SUNDRY NOTICES AND REPORTS ON WELLS

5. Lease Serial No. NMNM05039A
6. If Indian, Allottee or Tribe Name
7. If Unit or CA/Agreement, Name and/or No. 891000303X
8. Well Name and No. POKER LAKE UNIT 21 BD 121H
9. API Well No. 30-015-45513-00-X1
10. Field and Pool or Exploratory Area PURPLE SAGE-WOLFCAMP (GAS)
11. County or Parish, State EDDY COUNTY, NM

XTO Permian Operating, LLC requests permission to make the following changes to the original APD:

PECOS DISTRICT DRILLING CONDITIONS OF APPROVAL

11-3/4" x 8-5/8" x 5-1/2" 10M RSH-2 Wellhead
Assembly, With T-EBS-F Tubing Head

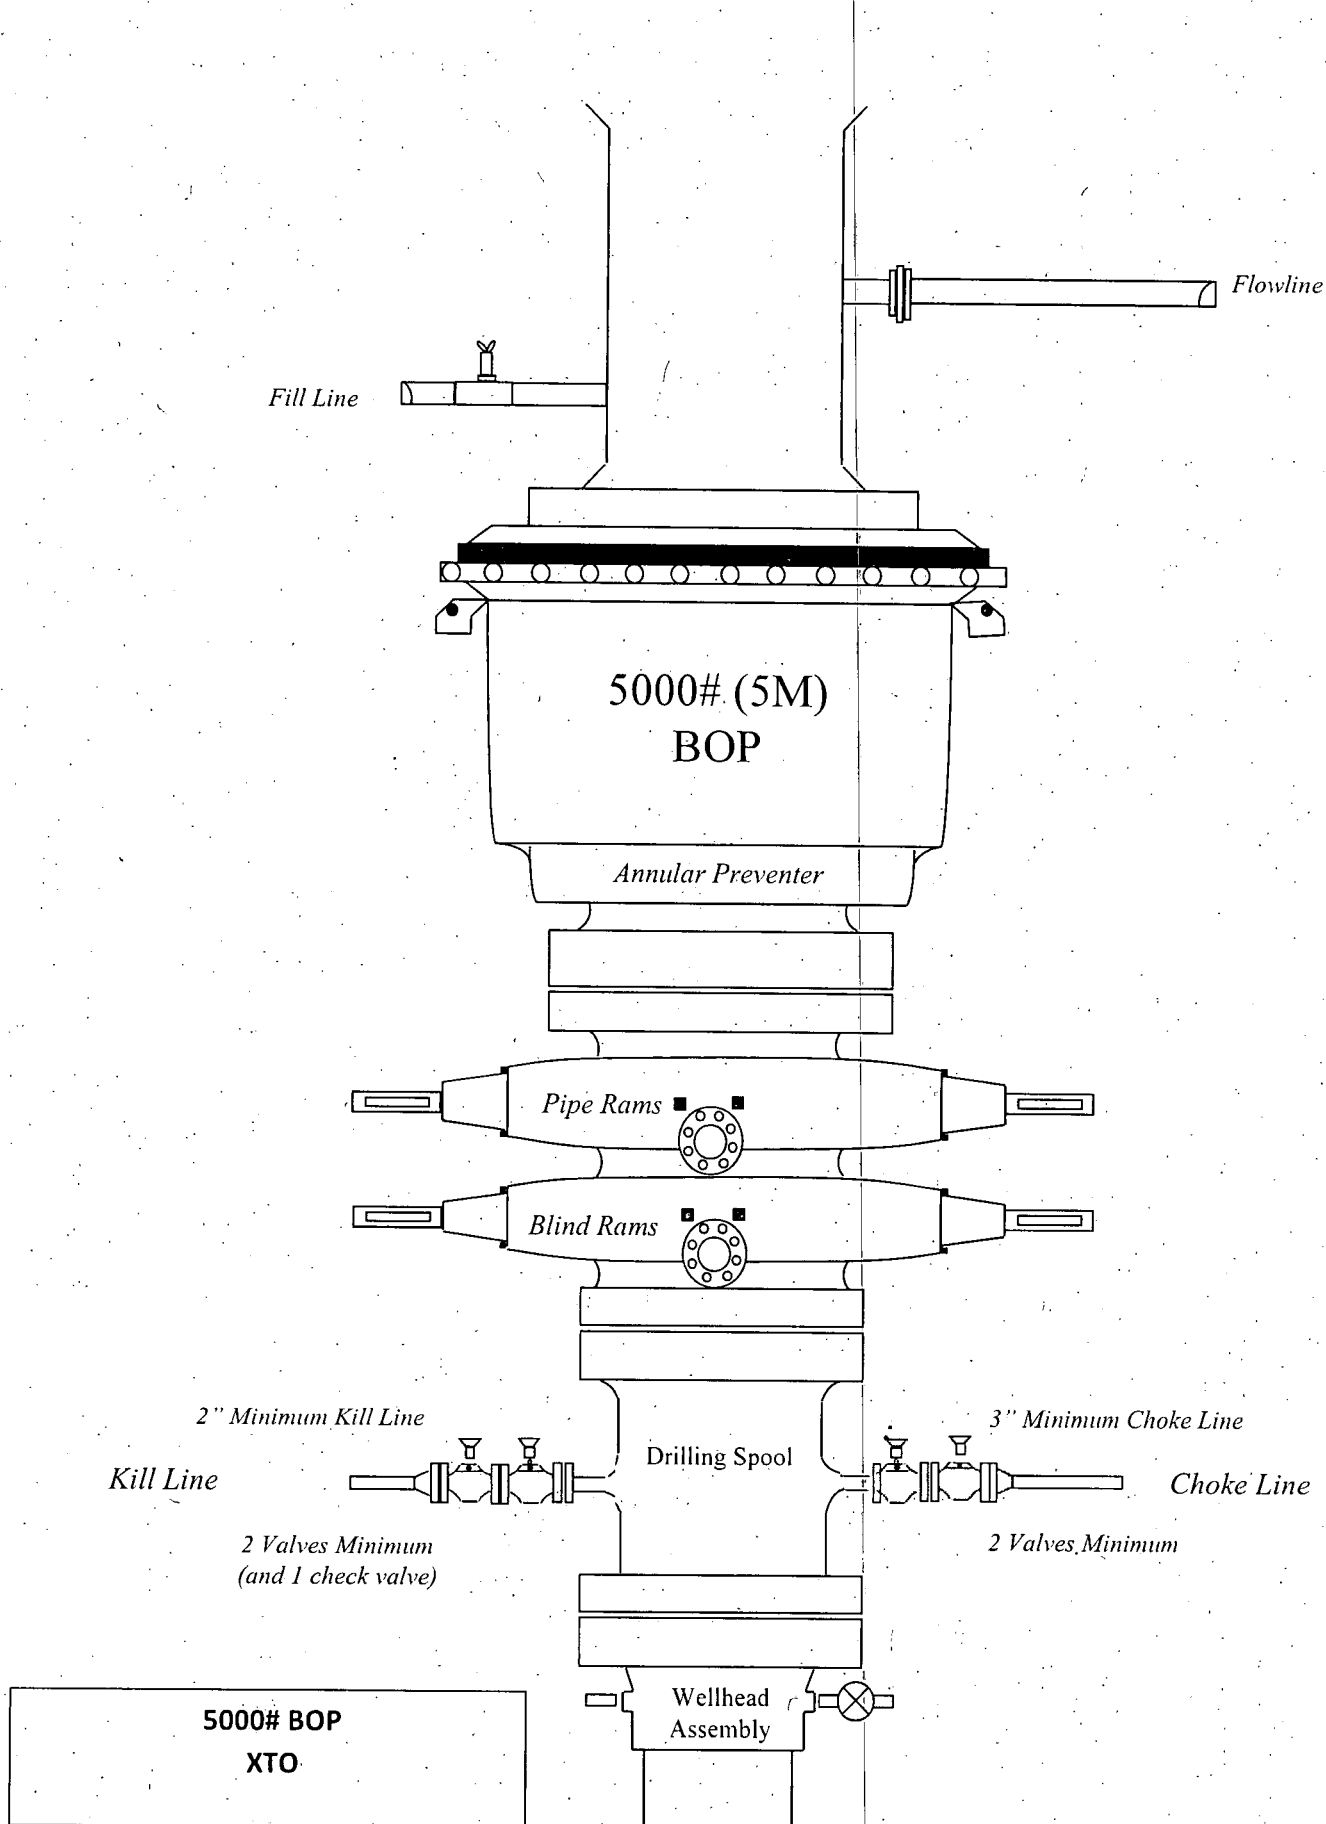
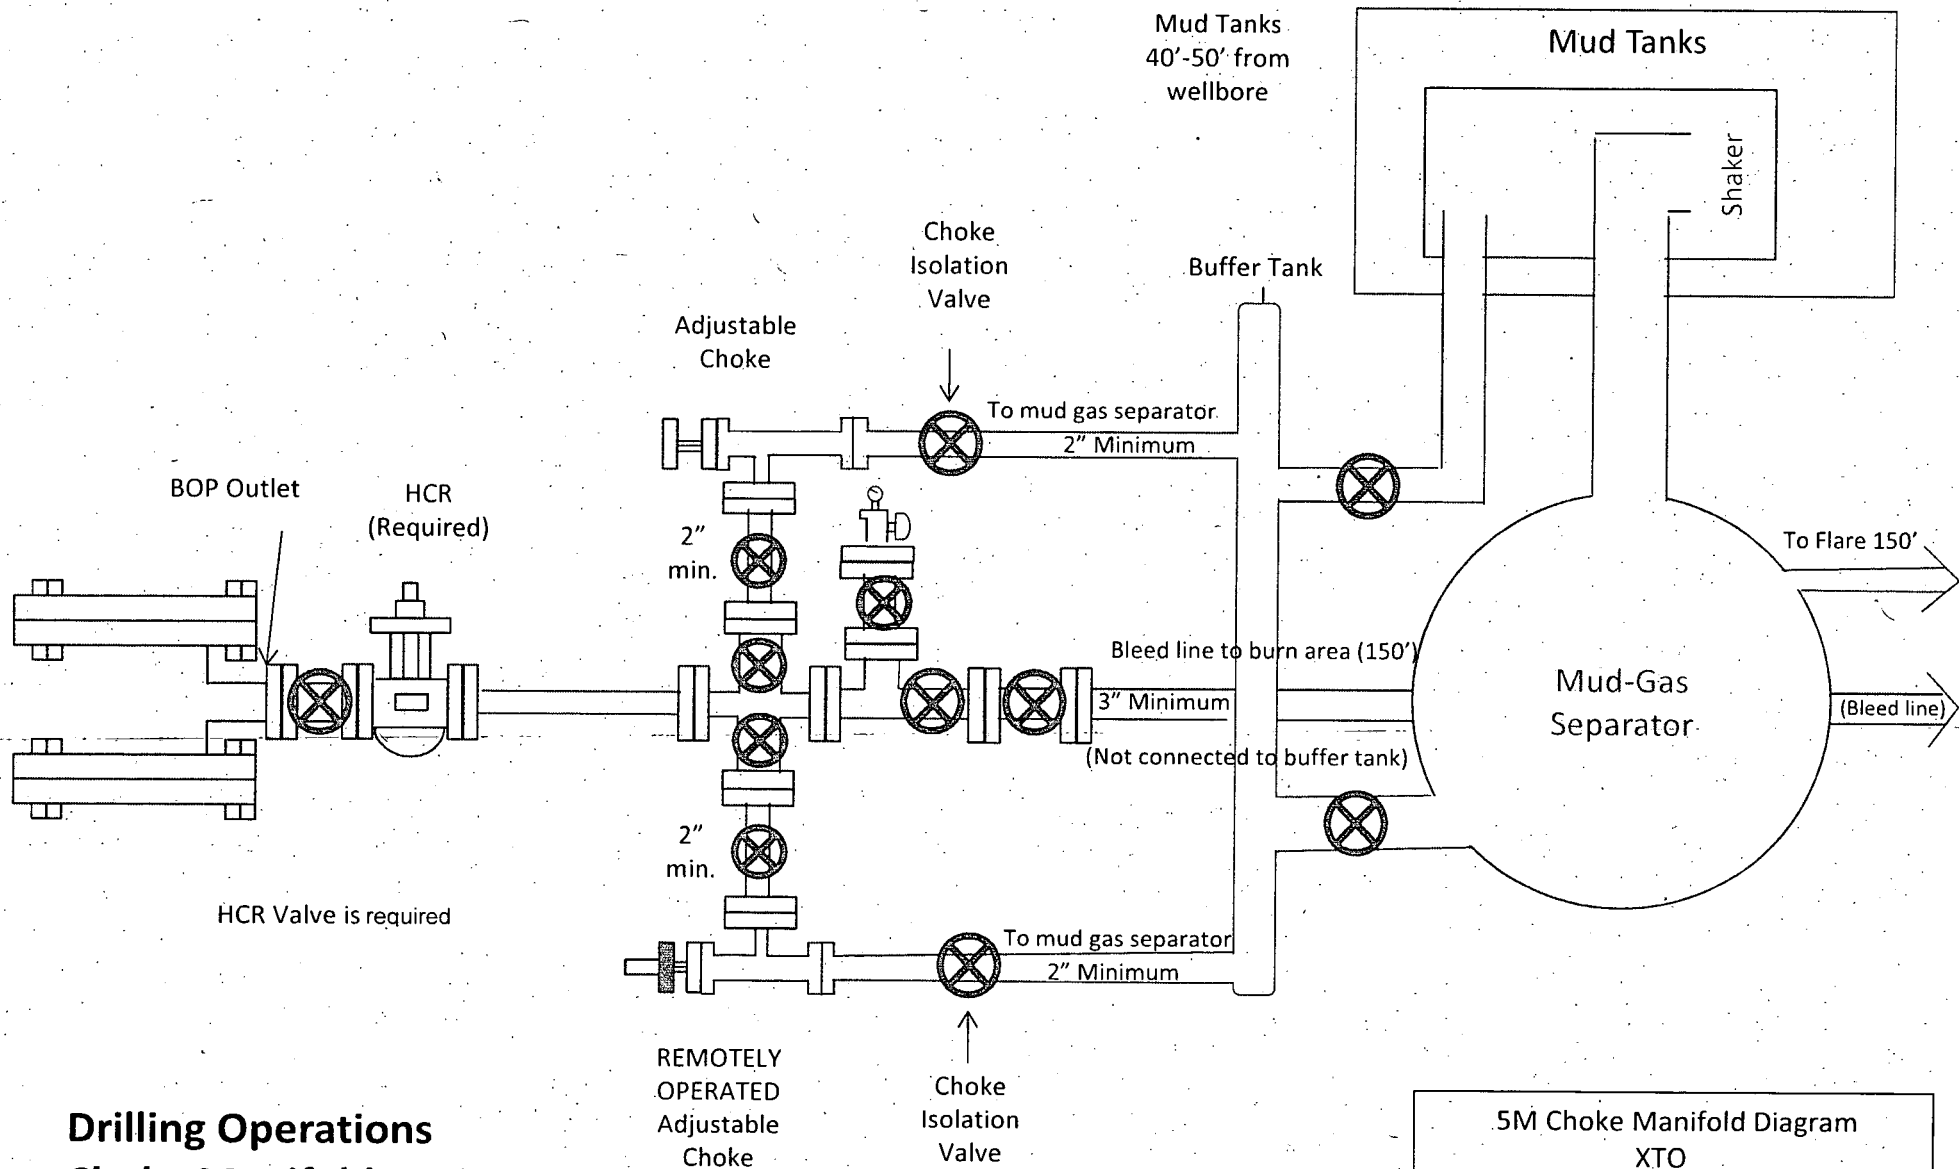
Permanent Wellhead = GE RSH Multibowl System

A. Starting Head (RSH System): 11-3/4" SOW bottom x 13-5/8" 5M top flange

B. Tubing Head: 13-5/8" 5M bottom flange x 7-1/16" 10M top flange

- Wellhead will be installed by manufacturer's representatives.
- Manufacturer will monitor welding process to ensure appropriate temperature of seal.
- Operator will test the 8-5/8" casing per Onshore Order 2.
- Wellhead manufacturer representative may not be present for BOP test-plug installation

2. Operator has proposed a multi-bowl wellhead assembly. This assembly will only be tested when installed on the surface casing. Minimum working pressure of the blowout preventer (BOP) and related equipment (BOPE) required for drilling below the surface casing shoe shall be **5000 (5M) psi**.

- a. Wellhead shall be installed by manufacturer's representatives, submit documentation with subsequent sundry.
 - b. If the welding is performed by a third party, the manufacturer's representative shall monitor the temperature to verify that it does not exceed the maximum temperature of the seal.

- c. Manufacturer representative shall install the test plug for the initial BOP test.
 - d. If the cement does not circulate and one inch operations would have been possible with a standard wellhead, the well head shall be cut off, cementing operations performed and another wellhead installed.

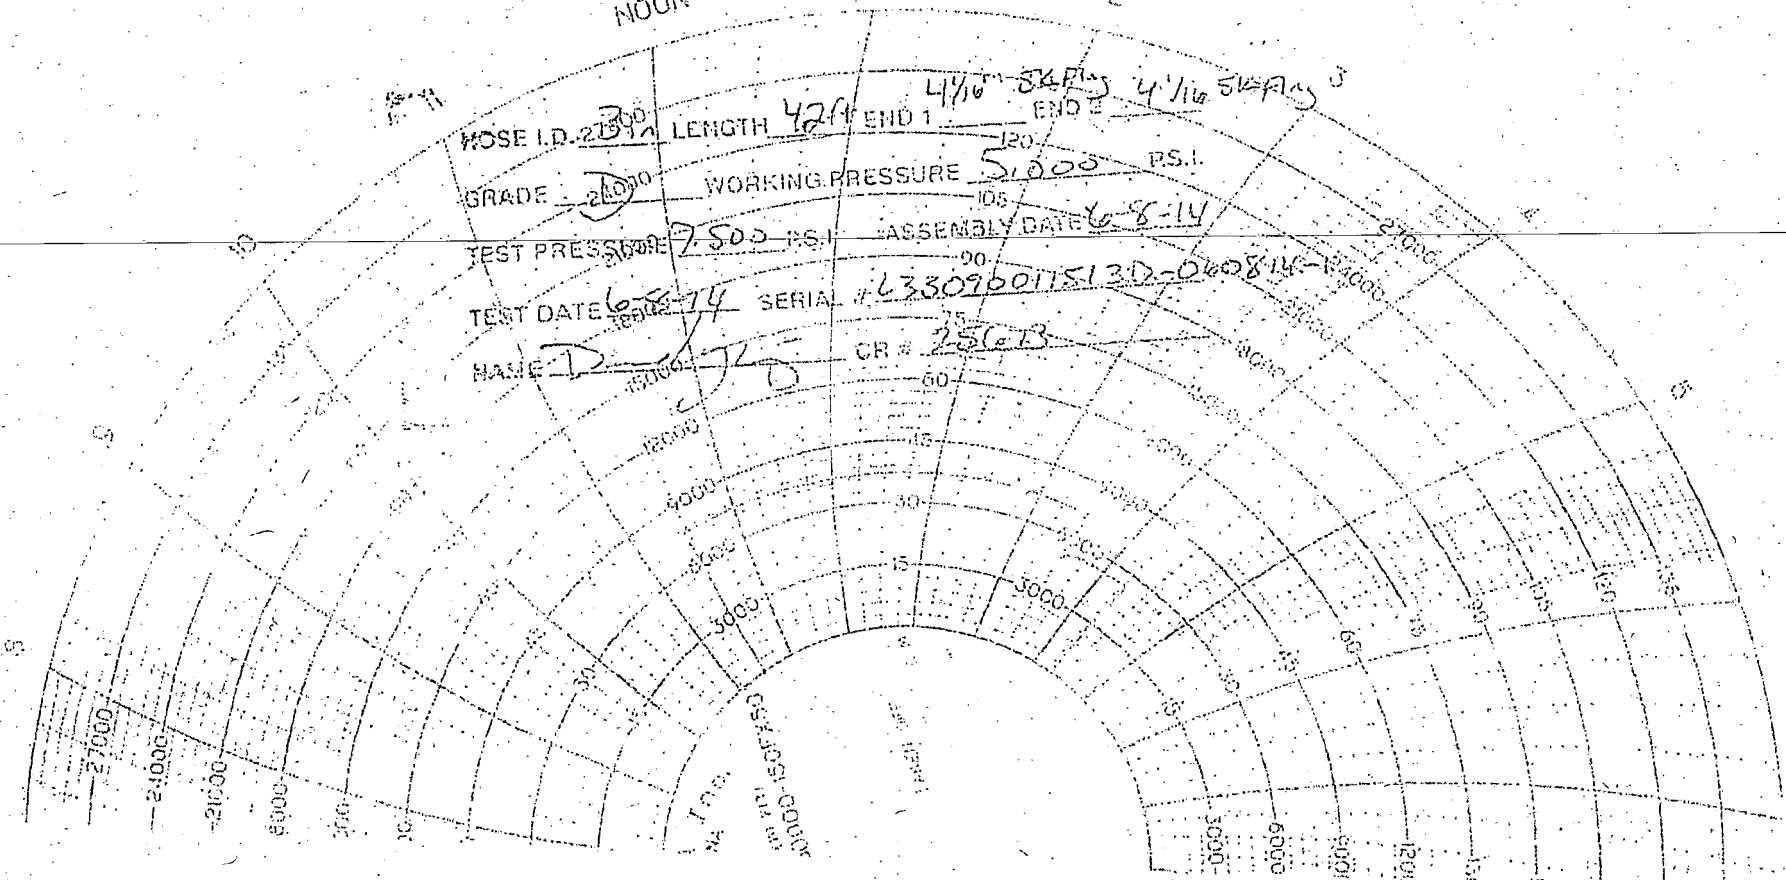
A variance is requested to allow use of a flex hose as the choke line from the BOP to the Choke Manifold. If this hose is used, a copy of the manufacturer's certification and pressure test chart will be kept on the rig. Attached is an example of a certification and pressure test chart. The manufacturer does not require anchors.

1. Variance approved to use flex line from BOP to choke manifold. Manufacturer's specification to be readily available. No external damage to flex line. Flex line to be installed as straight as possible (no hard bends).

2. If a variance is approved for a flexible hose to be installed from the BOP to the choke manifold, the following requirements apply: The flex line must meet the requirements of API 16C. Check condition of flexible line from BOP to choke manifold, replace if exterior is damaged or if line fails test. Line to be as straight as possible with no hard bends and is to be anchored according to Manufacturer's requirements. The flexible hose can be exchanged with a hose of equal size and equal or greater pressure rating. Anchor requirements, specification sheet and hydrostatic pressure test certification matching the hose in service, to be onsite for review. These documents shall be posted in the company man's trailer and on the rig floor.
